The amendment revises the Heatup Limits Curve and the Cooldown Limits Curve for Unit No. 1.

SALEM NUCLEAR GENERATING STATION, UNIT NO. 1

Amendment No. 75
License No. DPR-70

SAFETY EVALUATION BY THE OFFICE OF NUCLEAR REACTOR REGULATION
RELATED TO AMENDMENT NO. 75 TO FACILITY OPERATING LICENSE NO. DPR-70

Figure 3.4-2 Salem Unit 1 Reactor Coolant System Heatup Limitations Applicable up to 10 EPY

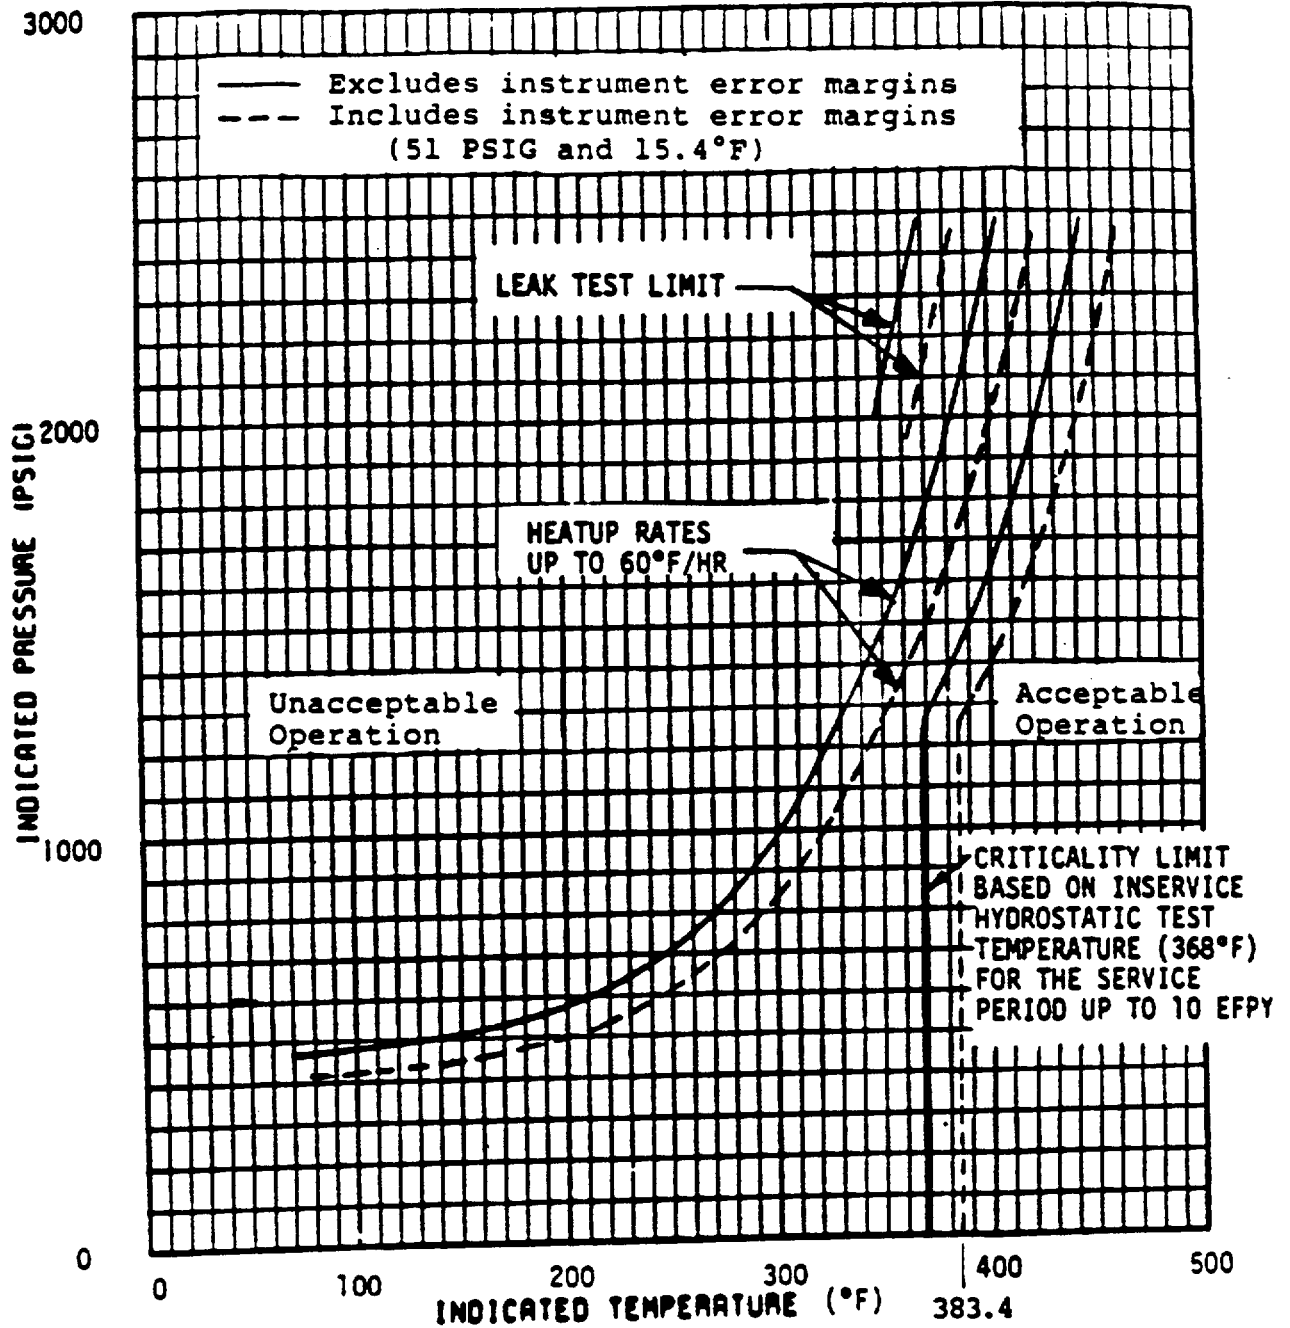
The heatup limit curve, Figure 3.4-2, is a composite curve which was prepared by determining the most conservative case, with either the inside or outside wall controlling, for any heatup rate up to 60°F per hour. The cooldown limit curves, Figure 3.4-3, are composite curves which were prepared based upon the same type analysis with the exception that the controlling location is always the inside wall where the cooldown thermal gradients tend to produce tensile stresses while producing compressive stresses at the outside wall. The heatup and cooldown curves were prepared based upon the most limiting value of the predicted adjusted reference temperature at the end of 10 EFPY.

CURVES APPLICABLE FOR HEATUP RATES UP TO 60°F/HR FOR THE SERVICE PERIOD UP TO 10 EPY
